Control arm bushing to fit Audi, Seat, Skoda, VW

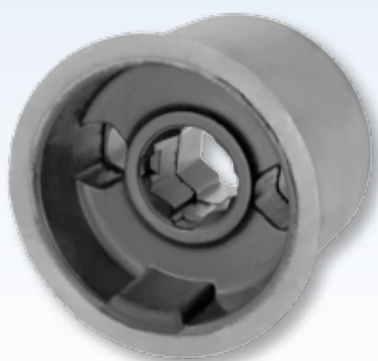
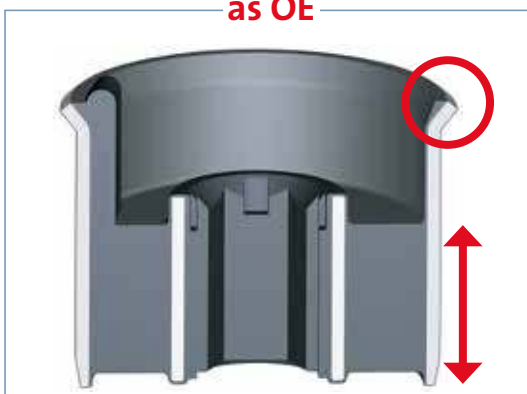
Problem

Rubber bearing does not provide enough cornering force and can wear out

Effect

Steering play, accurate lateral guidance no longer possible

Solution

Reinforcement of the critical rubber dimensions for enhanced bonding of the inner control arm mount to the outer sleeve

An optimised component with a longer service life
